Subject: Intermountain Power Agency (IPA) – Permit Change, Proposed Permit  
Boundary and Disturbed Area Increase  
Wildcat Loadout Facility, C/007/0033

## APPLICATION FOR COAL PERMIT PROCESSING

**Title:** PROPOSED PERMIT BOUNDARY AND DISTURBED AREA EXPANSION

## Detailed Schedule Of Changes to the Mining And Reclamation Plan

REVISION NUMBER: 7	SCALE: 1" = 150'
PROPOSED DISTURBED AREA EXPANSION	DATE: JUNE 2014
PLATE 1

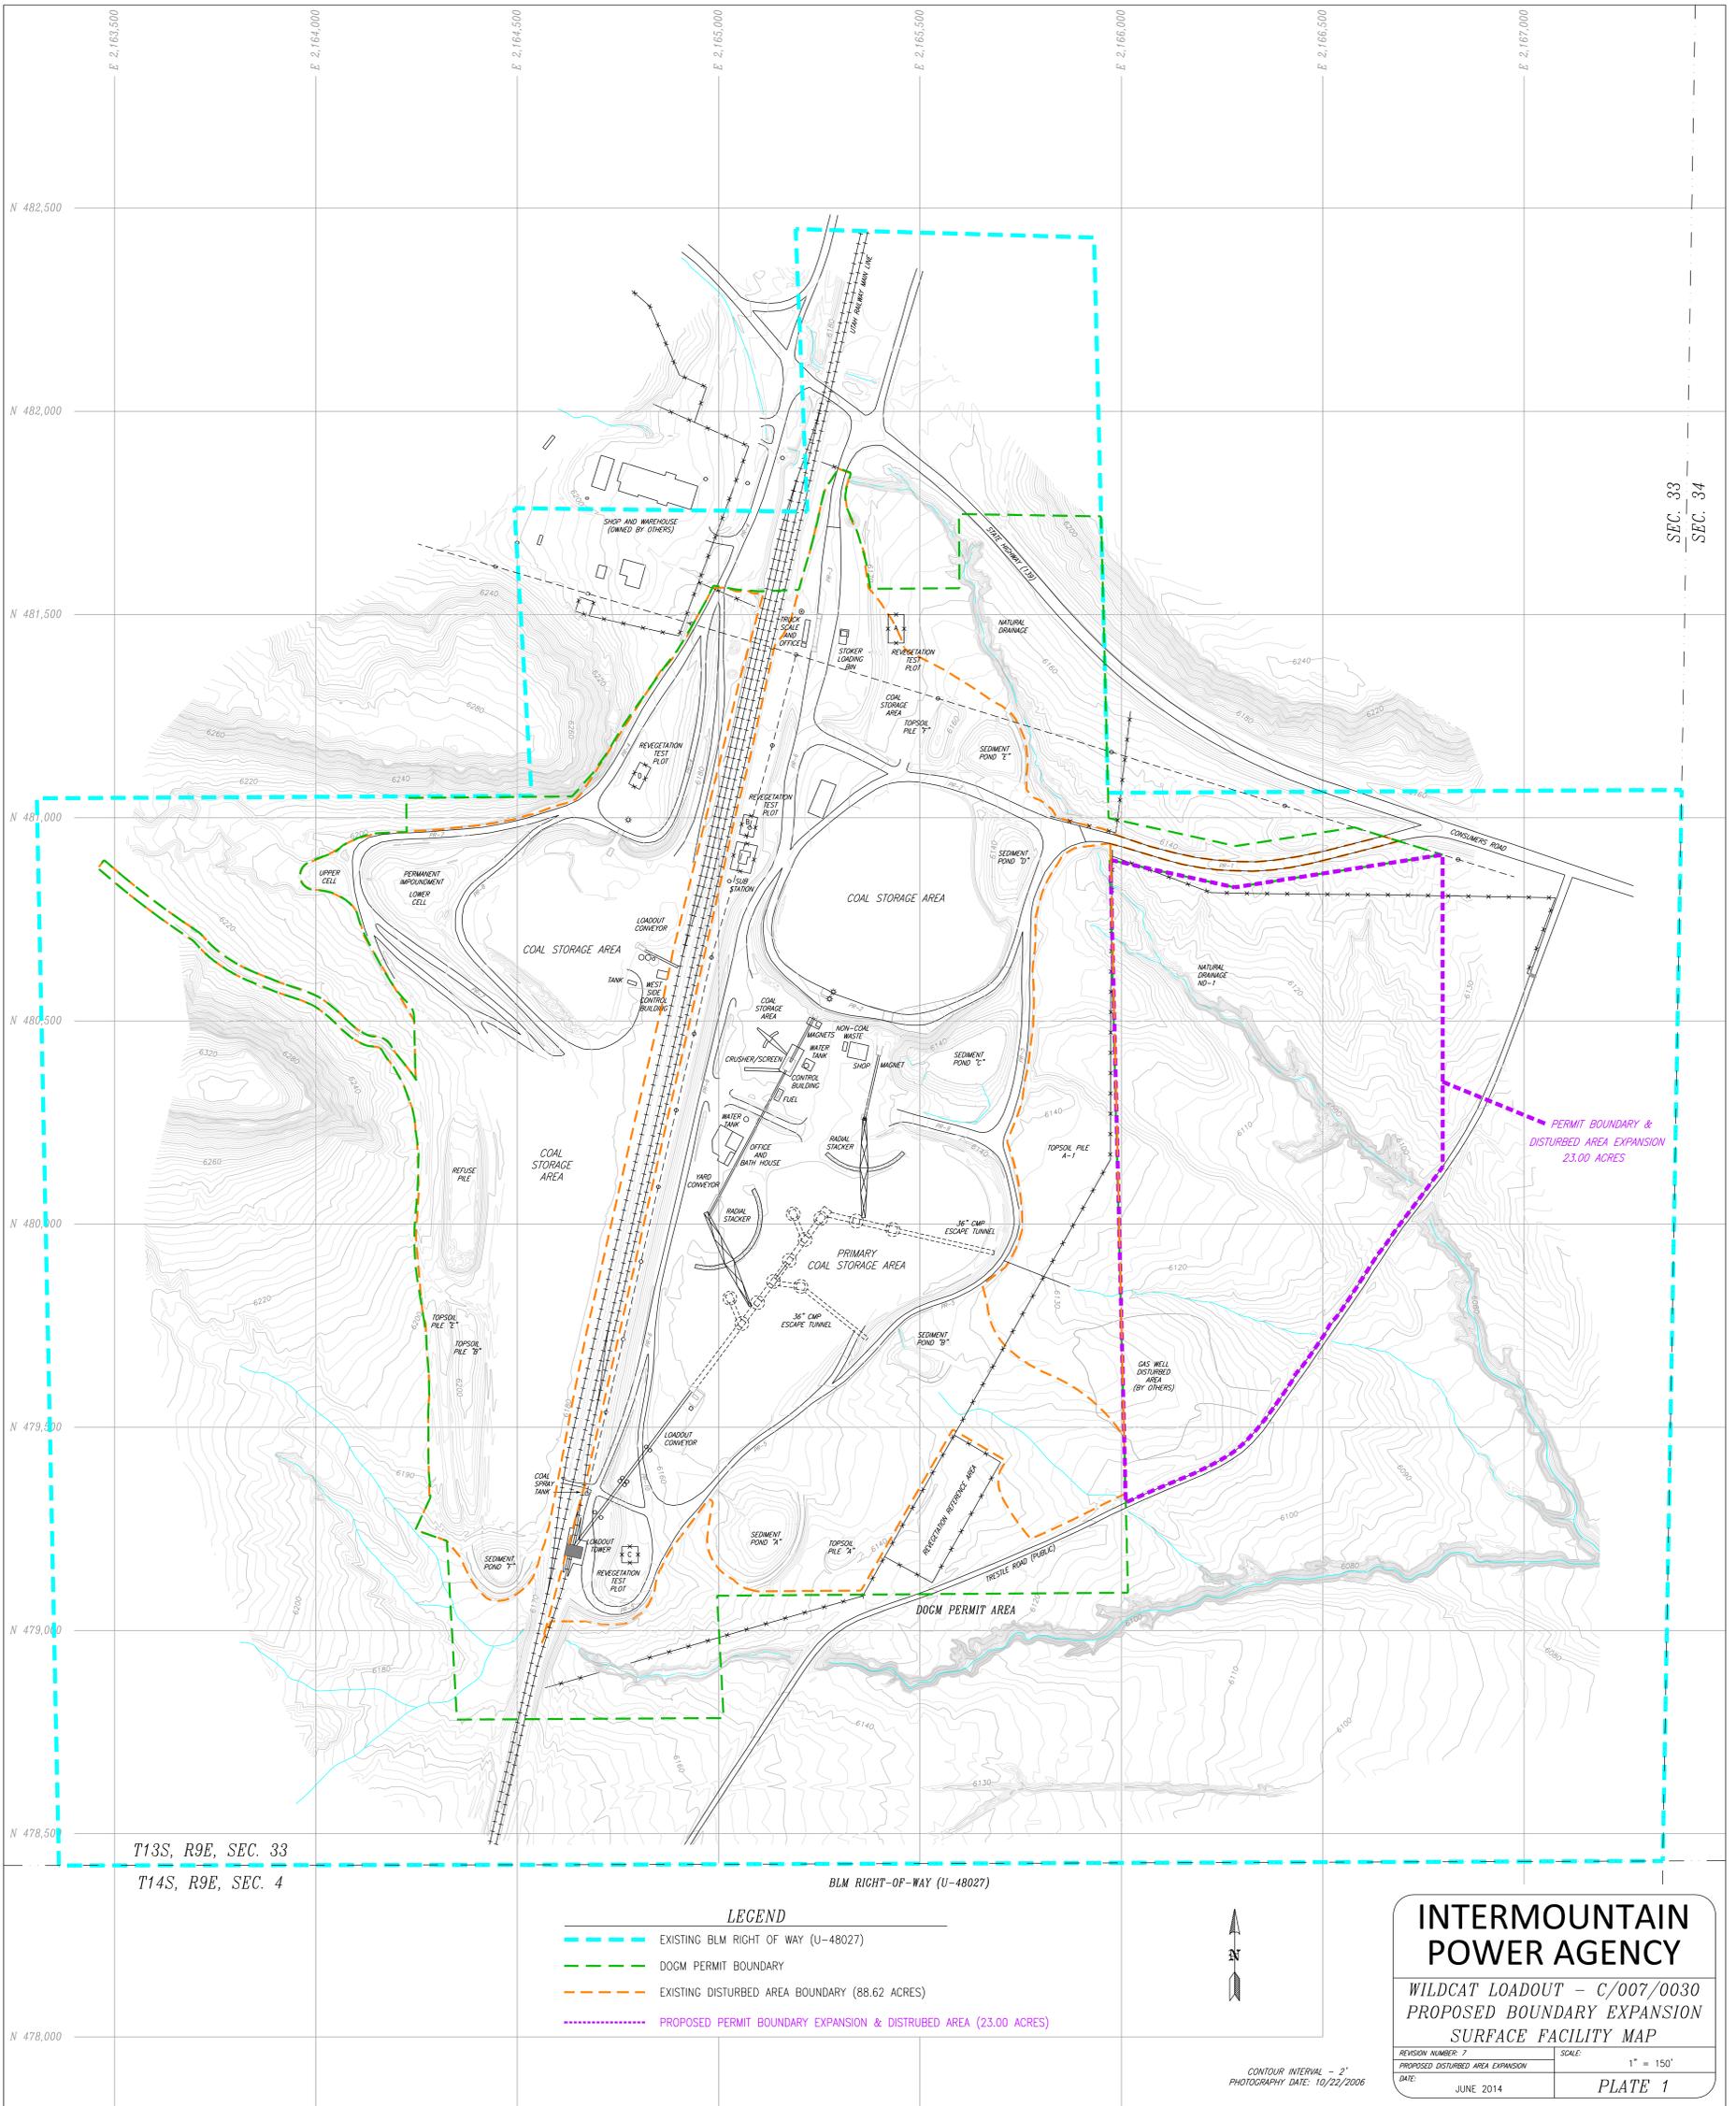
upon final reclamation, the entire disturbed area of approximately ~~88.62~~111.62 acres can be resurfaced with six inches of topsoil or less if allowed by the Division (please see Plate 1 for the location of these topsoil substitute areas. They are identified on Plate 1 as revegetation test plots.) Existing topsoil piles on site total approximately 464,499 cubic feet (17,204 cubic yards) of material. IPA feels and it is apparent from the soils inventory, that much of the fill material used onsite could be used as topsoil substitute. As previously mentioned, four topsoil substitute areas have been identified and are shown on Plate 1. Soil samples from these locations have been analyzed and the results are included in Appendix N. Once it has been determined that the substitute material is suitable for reclamation purposes, the actual area of substitute material will be carefully outlined on Plate 1 and the volumes included in the Topsoil Pile Summary. These areas have been protected from wind and water erosion through revegetation using the currently approved seed mixture. Please refer to Appendix D for the specific methods for this

Mulch will be used wherever seeds are planted. All disturbed areas will be reseeded. These areas are shown on Plate 1B and constitute ~~88.62~~111.62 acres. (Not including the Utah Railway tracks).

REVISION NUMBER:	5	SCALE:	1" = 150'
DATE:	DECEMBER 2014		PLATE 2A

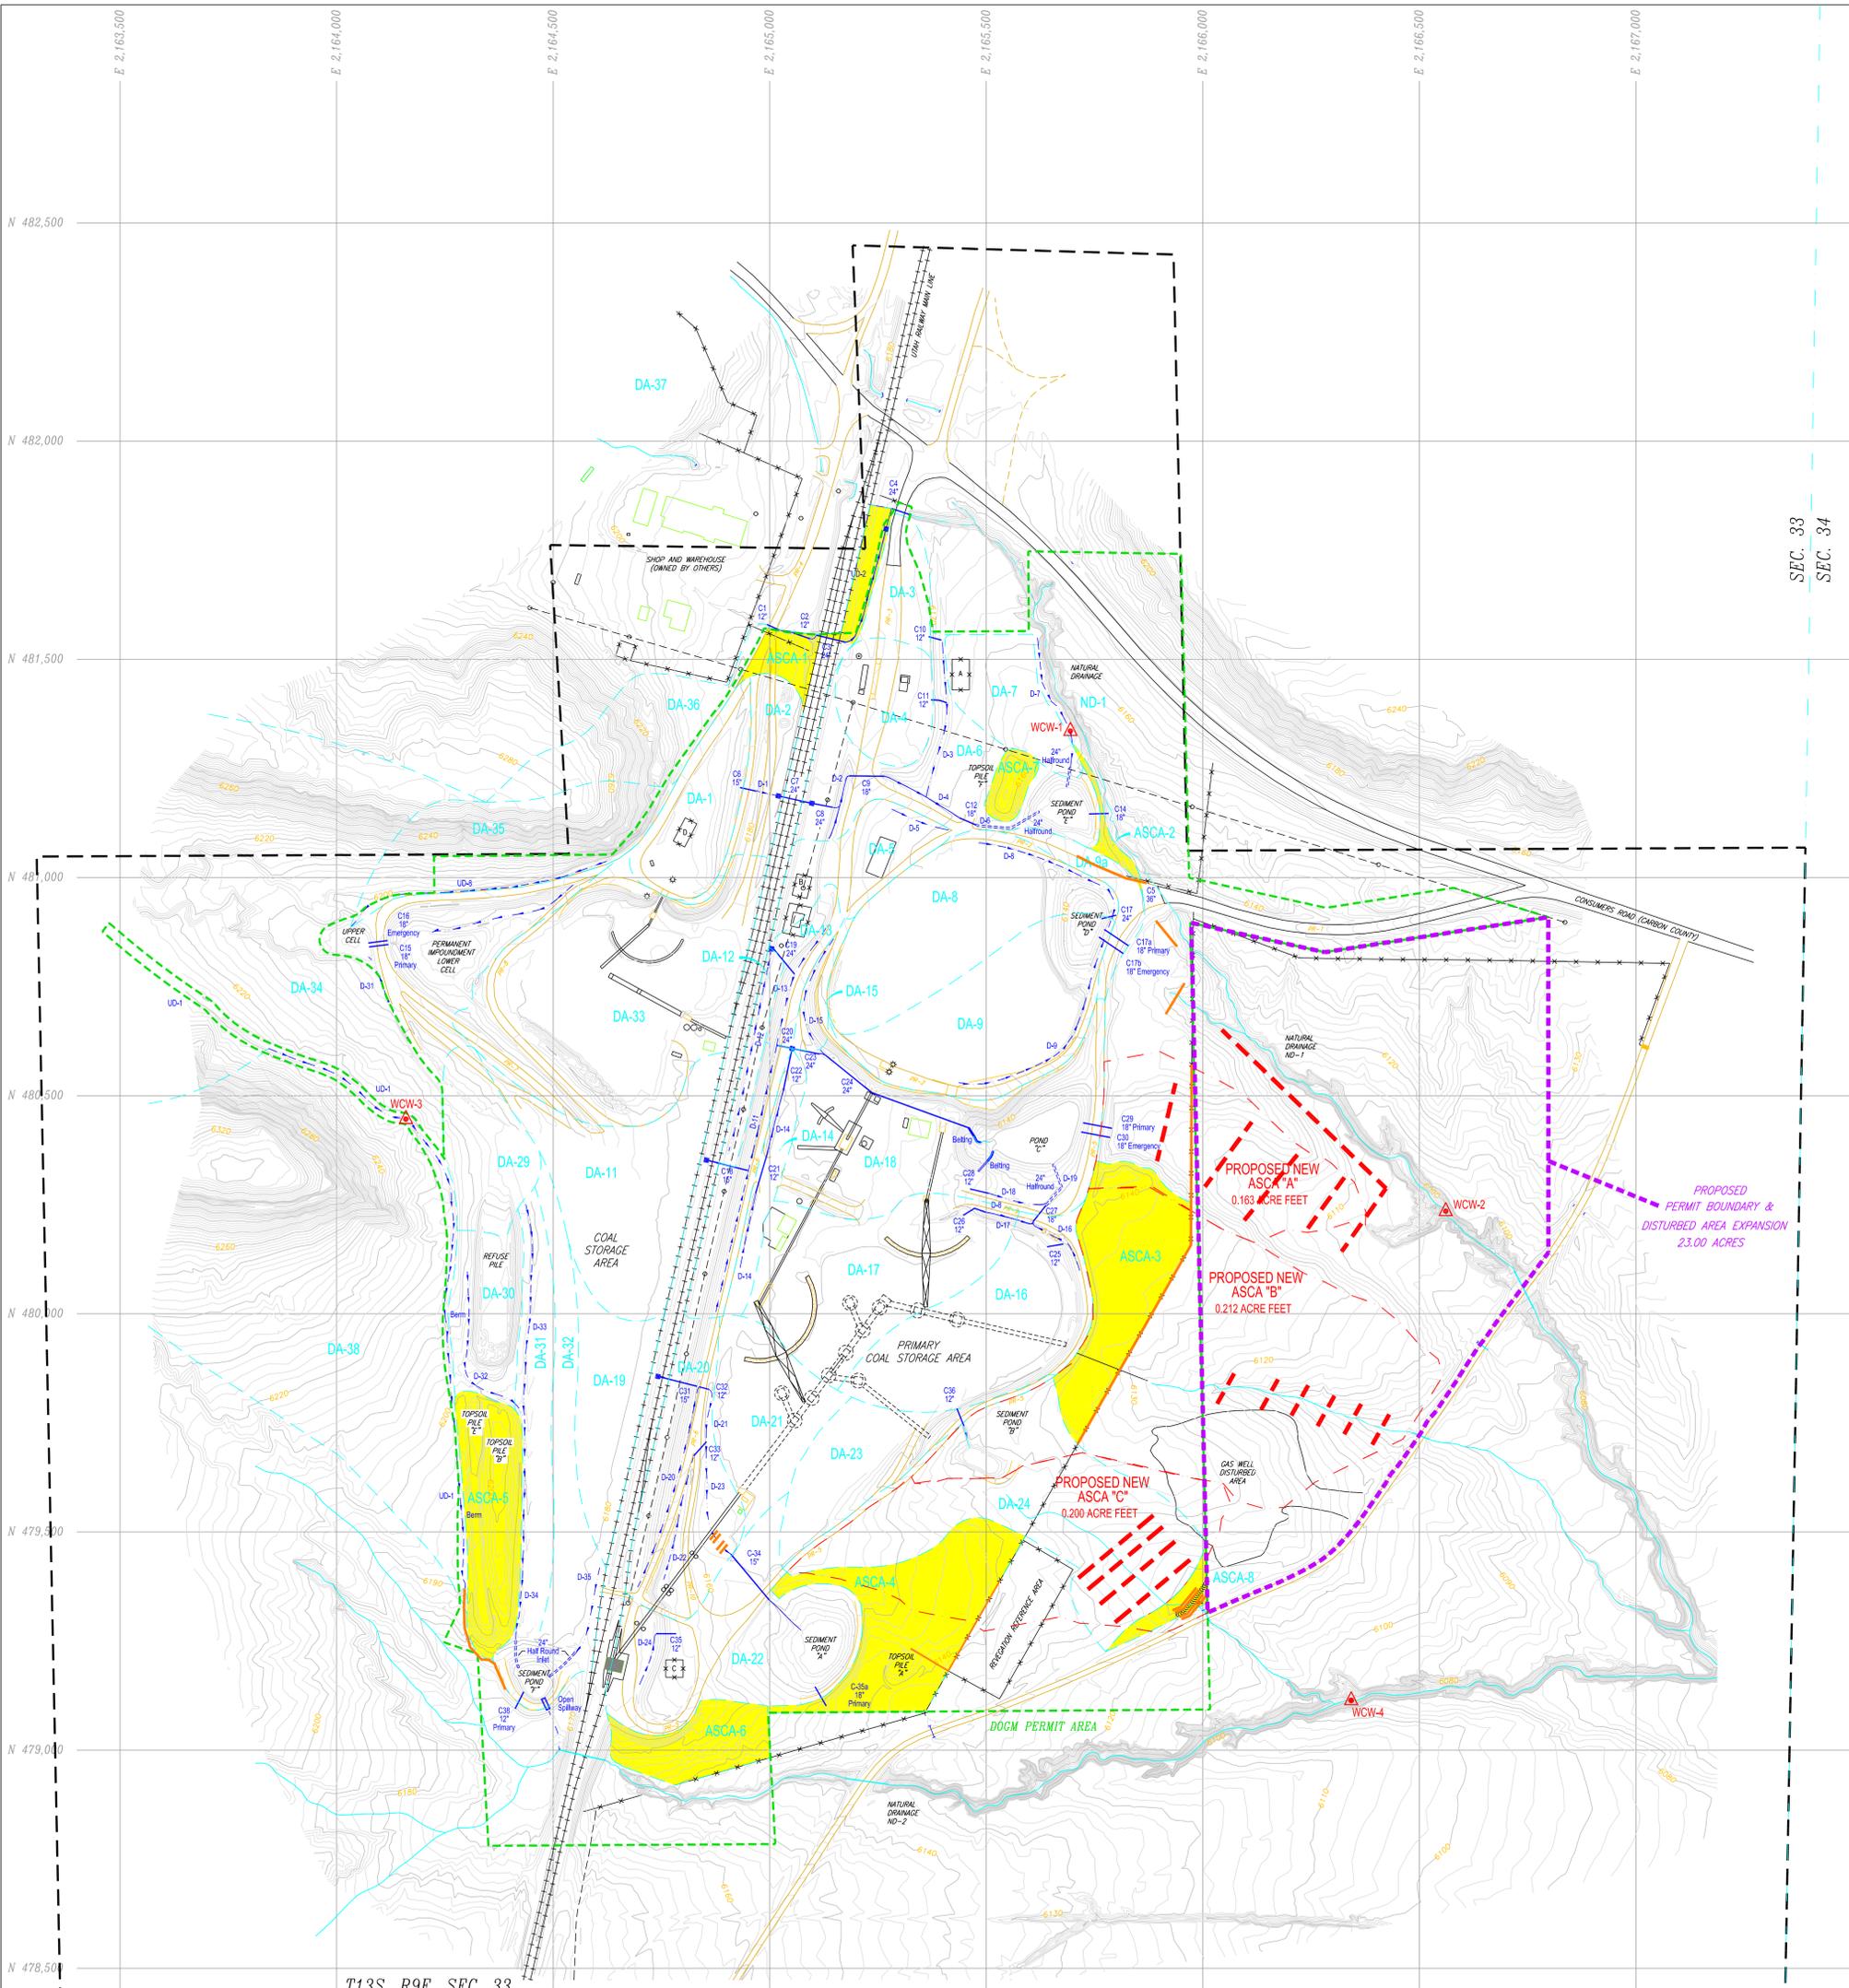
**ASCA-A- This will be a new ASCA located in the northernmost drainage of the proposed expansion area. It will have an area of approximately 3.62 acres and will be treated by vegetation and excelsior logs.**

**ASCA-B- This will be a new ASCA located in the center drainage of the proposed expansion area. It will have an area of approximately 6.84 acres and will be treated by vegetation and excelsior logs.**

**ASCA-C- This will be a new ASCA located in the southernmost drainage of the proposed expansion area. It will have an area of approximately 6.43 acres and will be treated by vegetation and excelsior logs.**

**The locations of the proposed new ASCA locations can be found on Plate 2a – Drainage Map**
